BACK RIVER GOLD MINE PROJECT WRMP, WMP, ICRP, & PRWP: COMMENT RESPONSES

BACK RIVER GOLD MINE PROJECT

WRMP, WMP, ICRP, PRWP:

RESPONSES TO REVIEW COMMENTS

Figure 1: Inflow and outflow volumes to the Saline Water Pond (SWP) and annual average TDS concentrations in SWP

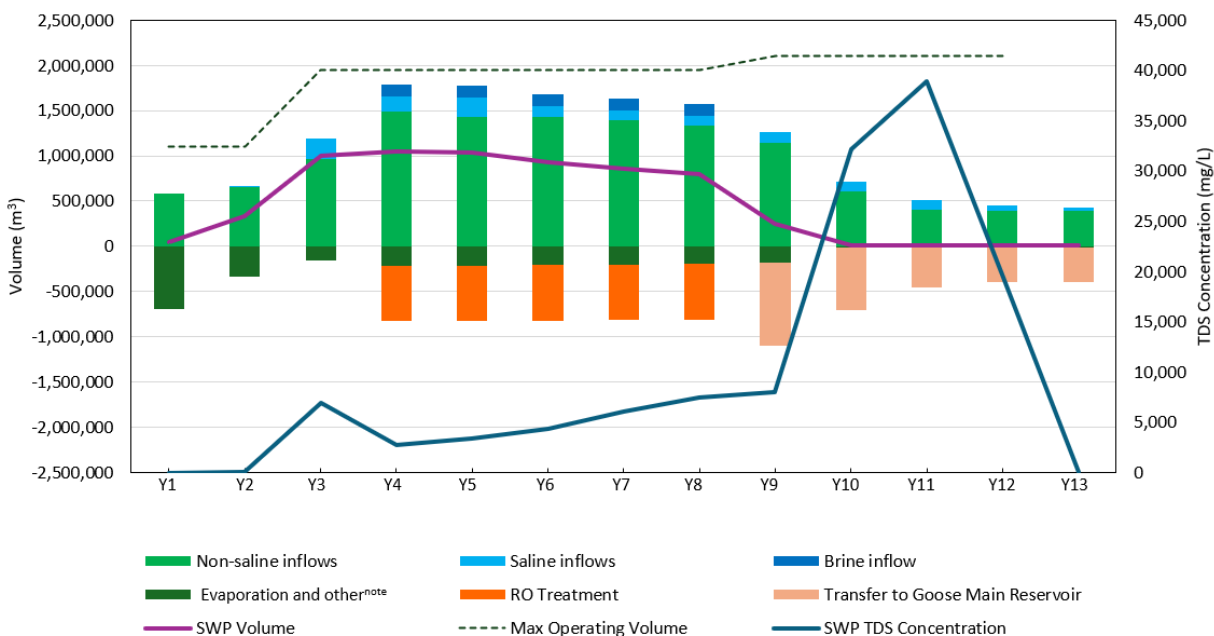
Until Goose Open Pit is completed, the salt water pond (SWP) will be used to store saline water and pond volumes are proposed to be managed by treating water with reverse osmosis (RO). The SWP salinity would increase over time since it is the proposed disposal location for the RO brine. SWP reclamation described in the Water Management Plan includes removing sediment from the pond bottom. The Saline Water Management Plan does not provide enough detail to confirm that proposed measures will adequately manage saline groundwater encountered during mining.

Recommendation: (R-07) CIRNAC recommends that B2Gold:

- a. Compare volumes of saline water generated with the capacity of the SWP over time;
- b. Describe the water quality in the SWP and how it evolves over time;
- c. Discuss how increasing salinity in the SWP will impact reverse osmosis treatment of water, and if it will change the proportion of brine generated; and
- d. Explain why removal of SWP sediment at closure is not included in the ICRP.

- a. Figure 1 presents the annual inflows and outflows to the Saline Water Pond (SWP), together with the annual average total dissolved solids (TDS) concentration, which is used as an indicator of

- b. TDS concentrations are predicted to increase during the initial years of saline water storage prior to commencement of RO treatment (Figure 1). Following implementation of RO treatment, TDS concentrations decrease as saline water is removed from the system, followed by a gradual increase associated with the return of concentrated RO brine to the pond. After transfers to Goose Main Reservoir begin in Year 9 (2033), annual average TDS concentrations increase for the next two years as the SWP is maintained at a low volume while continuing to receive saline groundwater. During this period, TDS concentrations are more representative of the chemistry of the saline groundwater inflows because freshwater inflows occur primarily during the freshet period, whereas groundwater inflows occur throughout the year. TDS concentrations decrease in the last two years of operations (2036 to 2037) as the groundwater inflows to the SWP decrease. Figure 1 shows that the predicted volume of saline water generated during operations remains within the available storage capacity of the SWP and that implementation of RO treatment, followed by transfer of water to Goose Main Reservoir, provides sufficient capacity to manage saline water throughout the operating period.

Figure 2 Predicted total reservoir water elevation, saline water layer elevation, and freshwater layer depth in Goose Main Reservoir. Saline water layer elevations were estimated assuming ideal meromictic conditions

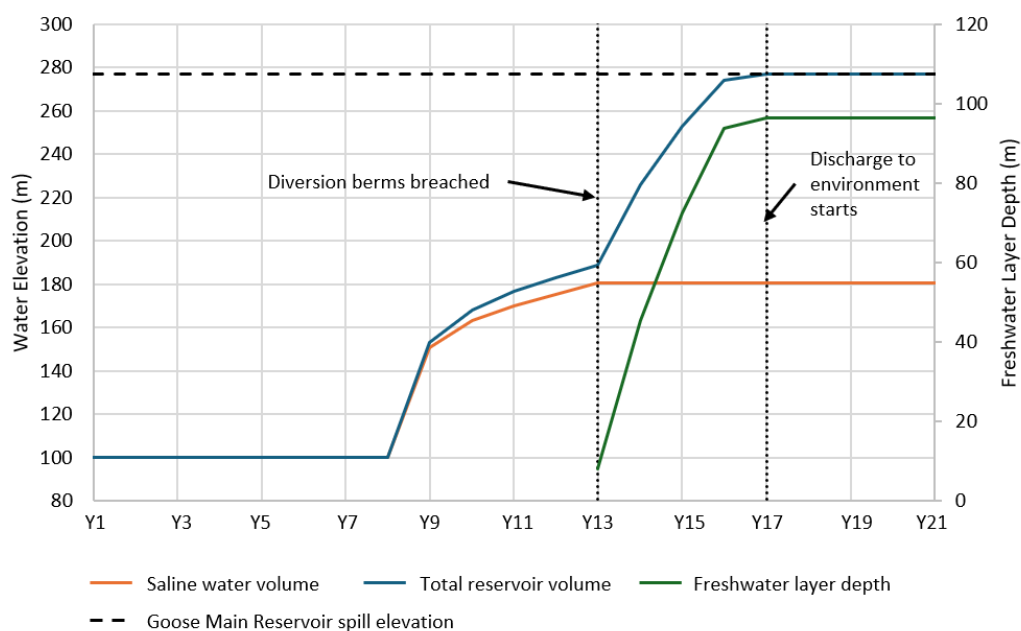
The proposal to use Goose Main Reservoir as the primary saline water repository means its successful reclamation at closure becomes critical. The ICRP does not provide sufficient detail on meromictic conditions to provide confidence in this proposed methodology. CIRNAC has concerns about long-term environmental risks if stratification fails. The Water Balance and Load Model predict a median modelled chloride concentration at the outflow of the Goose Main Reservoir right at long-term Canadian Council of Ministers of the Environment (CCME) criteria for the protection of aquatic life (120 mg/L) the first year of post-closure. The Water Balance and Load Model assume meromictic conditions in the pit so any difficulties would increase chloride concentrations in the outflow. This is far from a conservative assumption since it predicts a 50% probability the chloride criteria will be exceeded in the Goose Main Reservoir.

- c. At closure, the Goose Main diversion berms and Rascal Diversion berms are breached, increasing freshwater inflows to the reservoir. As a result, the freshwater cap rapidly increases, reaching approximately 45 m (Figure 2) after the first year of the diversion being breached. Over the same period, the saline water fraction decreases to approximately 36% of the reservoir volume and continues to decline as the reservoir fills. At full reservoir capacity, saline water is predicted to represent approximately 16% of the total reservoir volume. The evolution of saline water layer and total reservoir volume and the freshwater cap thickness is presented in Figure 2. The water quality predictions presented in the Water and Load Balance Model (BGC, June 25, 2026) assume that individual reservoirs and ponds are fully mixed. Under this approach, constituent loads are distributed throughout the entire reservoir volume and do not explicitly account for the lower concentrations that would be expected within an overlying freshwater layer if density stratification develops (i.e., meromictic conditions). As a result, the modelled reservoir concentrations do not reflect the potential isolation of the deeper saline layer and therefore represent a conservative estimate of overall reservoir water quality. Figure 3 compares the modelled total dissolved solids (TDS) concentrations in Goose Main Reservoir under the fully mixed assumption with preliminary estimates of concentrations in the saline layer. Saline layer concentrations were estimated separately by tracking saline inflows within an independent model node, providing an upper-bound estimate of saline water chemistry. Some mixing between the saline and freshwater layers would be expected, particularly during the early stages of pit filling when saline water comprises most of the reservoir volume.

Treatment of Goose Reservoir water prior to discharge remains a contingency measure within the closure plan. In the Water and Load Balance Model (BGC, June 25, 2026), treatment requirements were evaluated based on predicted discharge quality relative to applicable MDMER parameters. Chloride is not an MDMER-regulated parameter and was therefore not used as a treatment trigger in the model. However, this does not preclude treatment of Goose Reservoir outflows should monitoring indicate that treatment is required to achieve closure objectives or protect downstream aquatic life. Table 5-3 of the Water and Load Balance Report identifies chloride as one of the potential constituents subject to treatment, and the Water Management Plan states that treatment of Goose Main Reservoir water may be implemented during closure and post-closure, if required.

Figure 4 Conceptual location and alignment of the proposed water management structures associated with the proposed changes to the waste rock storage area

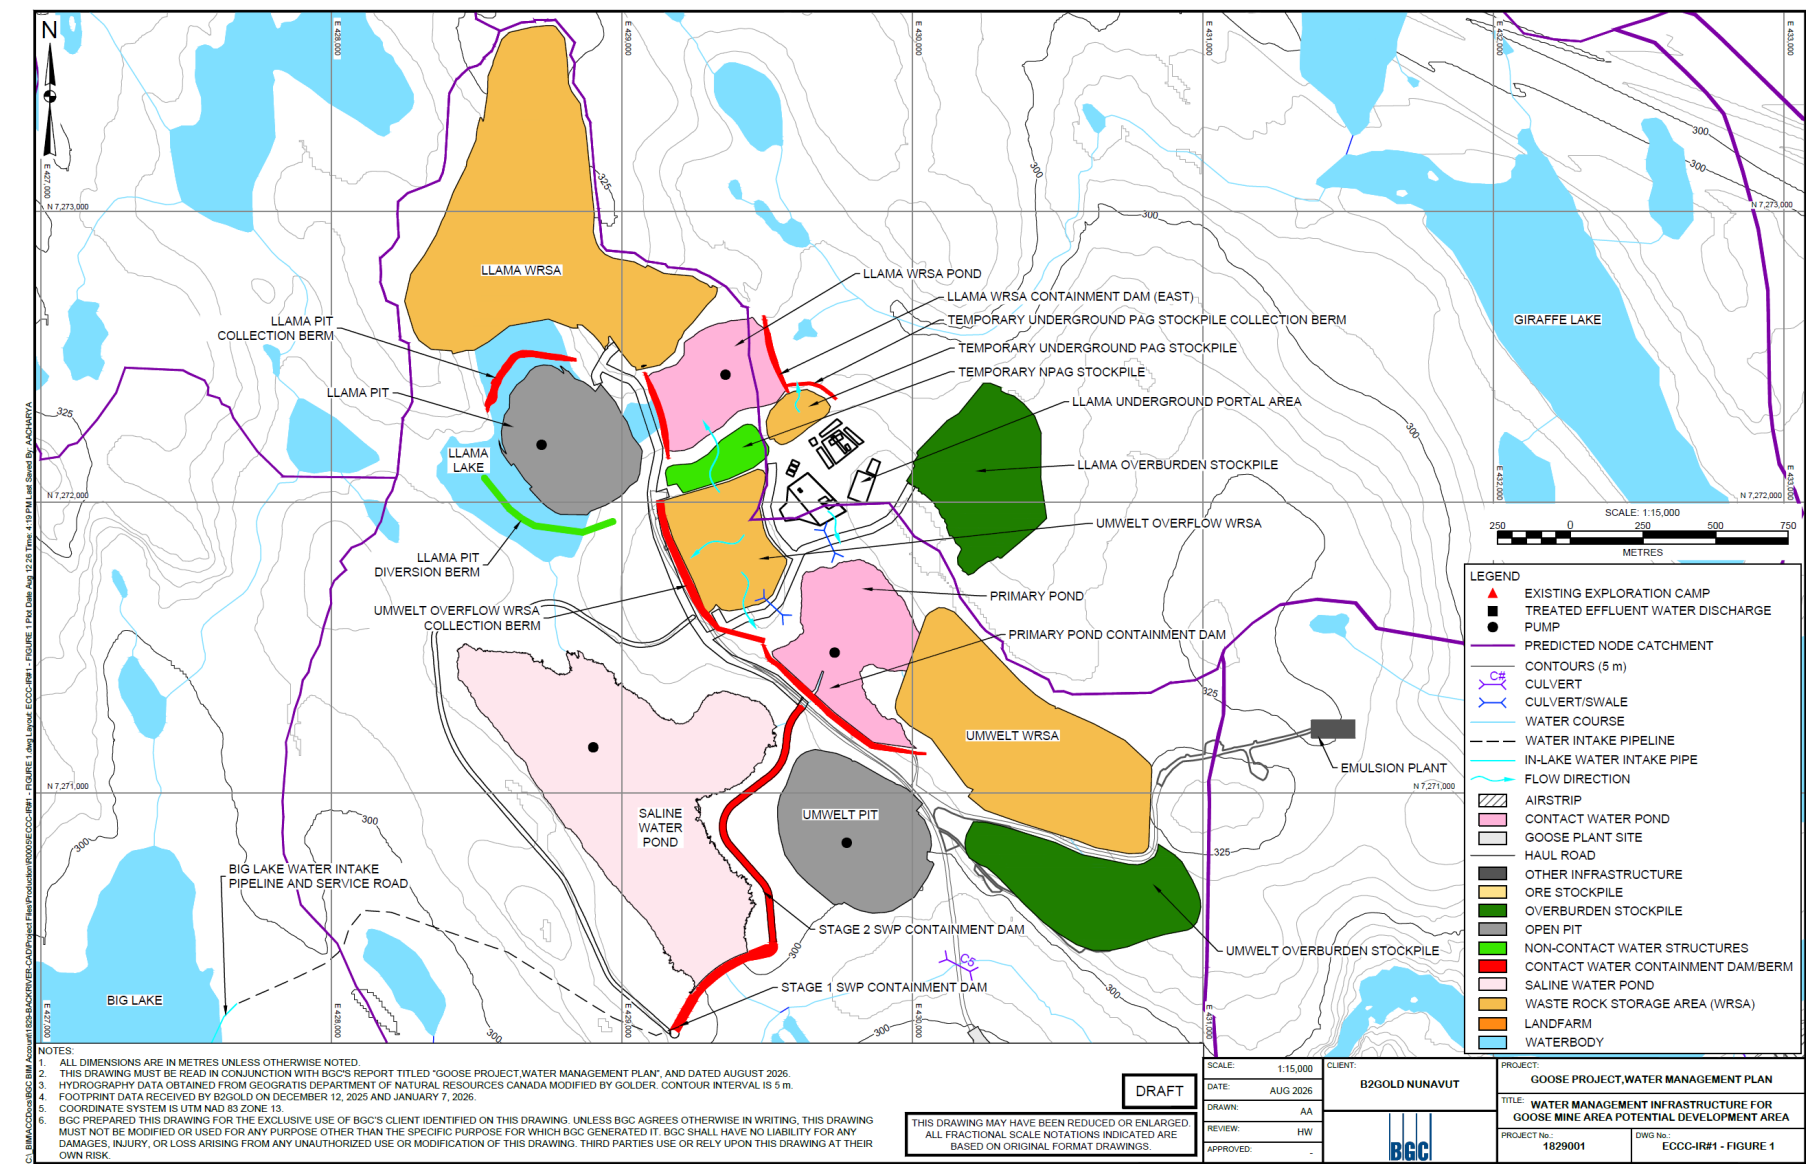
The modification proposes changes to the configuration and locations of the existing planned waste rock storage areas (WRSA) and includes the addition of a new waste rock storage area (Umwelt Overflow WRSA), two temporary waste rock stockpiles and the addition of three overburden stockpiles. The memo states that, “WRSA seepage and runoff will continue to be collected in perimeter berms and directed to collection and pumped to Primary Pond or the active Tailings Facility.” The memo states that all monitoring will remain consistent with the currently approved Water Management. Figure A-01 provides an updated site layout that includes the proposed modifications but does not clearly depict all associated water management infrastructure for the proposed waste rock and overburden storage areas, nor does it indicate flow directions. Given the expansion of waste rock and overburden storage piles on the site, additional water management infrastructure may be required to collect and manage seepage and runoff associated with these areas.

Recommendation: (R-1) ECCC recommends the Proponent provide:

1. A description of any new water management infrastructure (e.g., ponds, sumps, collection ditches, diversions) associated with the proposed changes to waste rock storage areas and overburden storage areas.
2. A figure depicting the proposed water management infrastructure and flow direction for runoff and seepage from the associated waste rock storage areas and overburden stockpiles.
3. A list of any new monitoring stations, or modifications to existing monitoring stations, required as a result of the modification or justify why existing monitoring is sufficient

environment only if it meets discharge limits. The design of the structures described above and shown in Figure 4 ECCC#1 is in progress and will be provided to NWB at least 60 days prior to construction in accordance with the Type A Water Licence (2AM-BRP1831 Amendment No. 1 Part D, Item 2). Please refer to the response to ECCC#3 for water management for the overburden stockpile areas.

2. Figure 4 shows the conceptual location and alignment of the proposed water management structures associated with the proposed changes to the waste rock storage areas.
3. Monitoring stations are within B2Gold compliance scope, and a comprehensive monitoring program is being conducted by B2Gold as per the Type A Water License 2AM-BRP1831 requirements (Amendment No.1).
